Planning and Rights of Way Panel

ADDITIONAL INFORMATION AND PRESENTATIONS

7 **22/00399/FUL 59 BURGESS ROAD** (Pages 1 - 18)

Ref Panel Meeting – 02/08/22 – Agenda Item 22-00399-FUL #59 Burgess Road

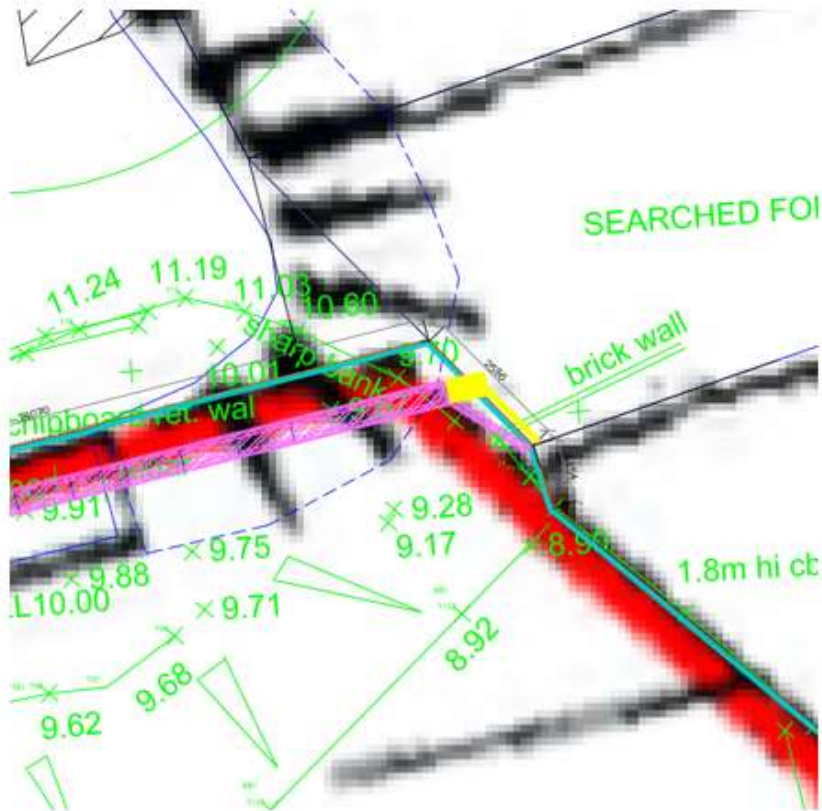
From the outset, it was clear that the applicant intended to aggressively encroach onto neighbouring properties, especially #27 Pointout Close. **Before the wall was built, affected neighbours wrote to Enforcement to alert them and were ignored. Enforcement simply refused to engage with the landowner. Council was informed by the landowner before building commenced, that permission would not be given for any encroachment. Things could have been stopped at this point but failures by Council Officers meant that they were not.** The Applicant has extended the retaining wall onto #27 Pointout Close and built a 1.8m high single skin block wall across the back of #27, entirely within #27's property, damaging the wall between #26 and #27 in the process. This wall is of very poor quality construction, with the piers on the structurally incorrect side and they then erected an orange plastic sheet several m high above it, which can be clearly seen from all neighbouring properties and the street.

Extract from PLAN_AND_TOPO_SITE_PLAN_OVERLAY-1675524 . Red = Applicant's version of title deed boundary (not 100% correct). Purple = applicant's lines showing end of retaining wall and single skin block wall. Yellow = our correction showing actual extent and orientation of built development.

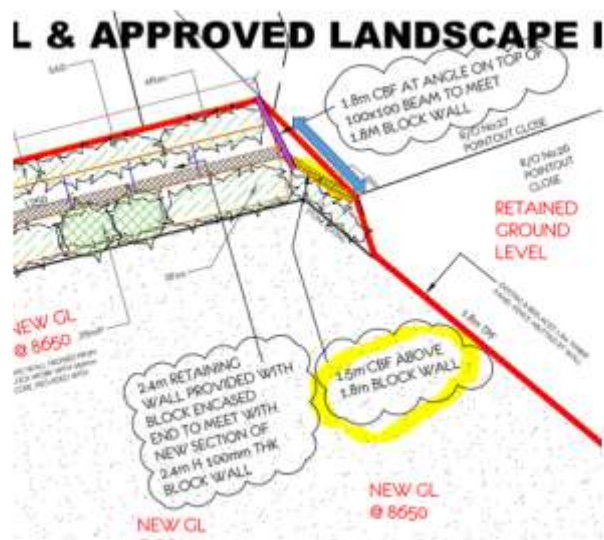
It is a criminal offence to knowingly make a false declaration on a planning application, and the applicant has done that multiple times. The Applicant, in all their previous planning applications has claimed ownership of all land affected by the proposal, contrary to the evidence of their title deeds which was pointed out to them by neighbours multiple times. Council has previously been provided with evidence in the form of text messages from the Applicant to a previous owner of #27 Pointout Close in which the Applicant was trying to purchase the ends of gardens in Pointout Close to gain a rear access route. The applicant knew full well that they didn't own the land but just went ahead with deliberate encroachment at a time when the owner of #27 was in a medically-induced coma with Covid and was powerless to prevent it. Finally a few weeks ago, the applicant submitted a Certificate B, which formally acknowledges that they do not own all the land. **A certificate B should be served at least 21 days before an application is submitted, not many months after.** It should also be publicised by council which it was not. Council could have dismissed the application at that stage and required a new submission based on correct ownership certificates and correct boundary placement but it did not. Then 3 new plans appeared, one of which overlays an approximation of the true title deed line on the OS data and shows clear encroachment and overbuild onto #27, albeit not as extensive as the actual encroachment.

Despite this, the remaining 2 new plans submitted at this time still use OS data to incorrectly define the boundary. They also clearly show the single skin wall in the wrong position and the wrong orientation. **The Case Officer report does not mention this. Why?**

In above, boundary Line is OS line, not title deed line. Actual position of 1.8m block wall is inset onto #27 and points in direction of blue arrow from end #26 / #27 boundary to end #27 / #28 boundary.

Yellow = true position.

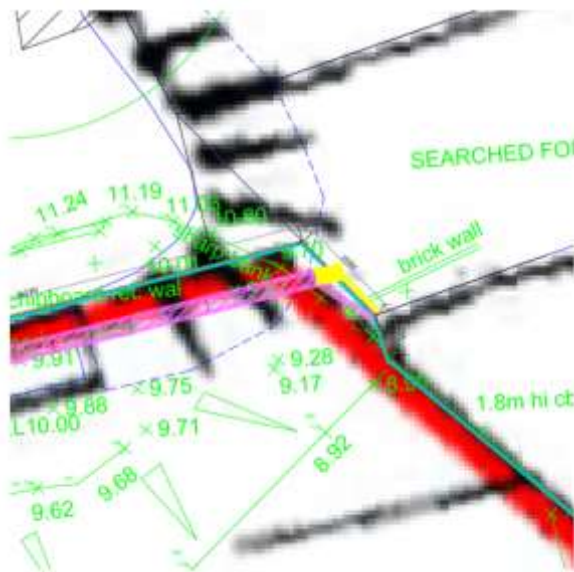
6.2.3 Development on neighbouring land	<p>The Officer fails to mention that the Applicant's version of the Land Registry / Title Deeds boundary on PLAN_AND_TOPO_SITE_PLAN_OVERLAY-1675524 is not 100% accurate. Why?</p> <p>The Officer fails to mention that the true extent of encroachment is not shown on PLAN_AND_TOPO_SITE_PLAN_OVERLAY-1675524, the retaining wall extends further than shown and the single skin block wall on #27 is in the wrong position and orientation. Why?</p>

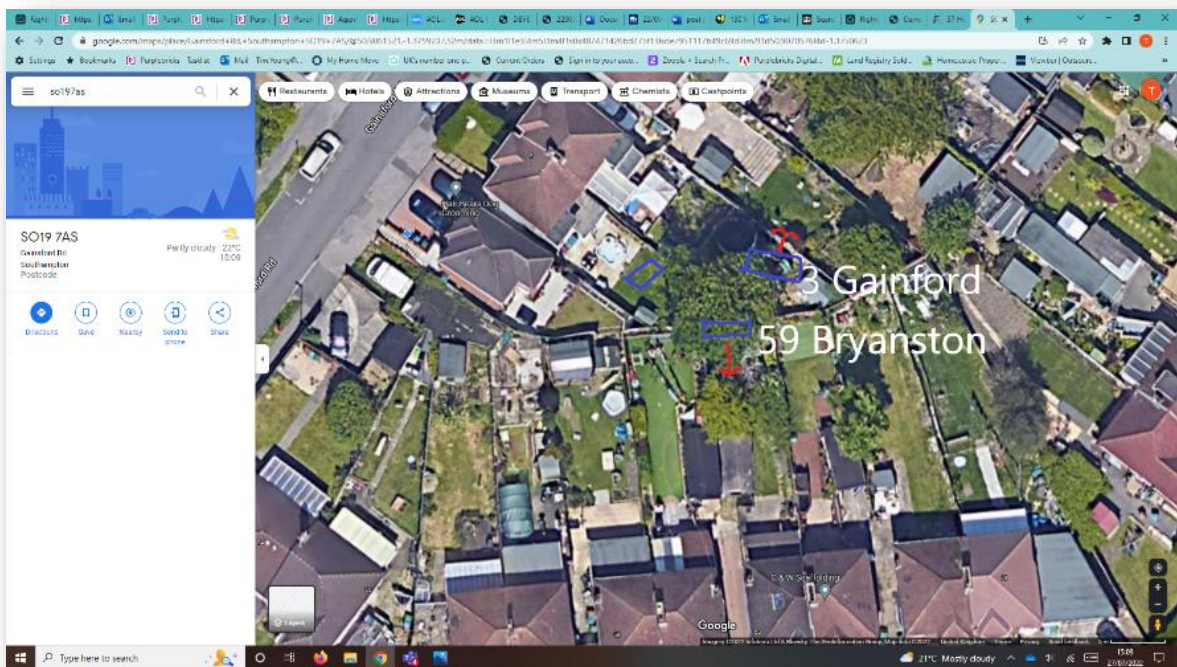
CH has failed to mention that these two properties have significantly larger gardens. Number 3 Gainsford Road has an approx 150ft garden and the outbuilding is set much further back and is not facing any neighbouring properties thus not causing any harm or loss of privacy to properties on Gainsford Road

Number 59 again has a very long garden as well and it is not raised on platform like the applicant 1 Gainsford Road thus not causing and loss of privacy/harm to properties on Branston Road.
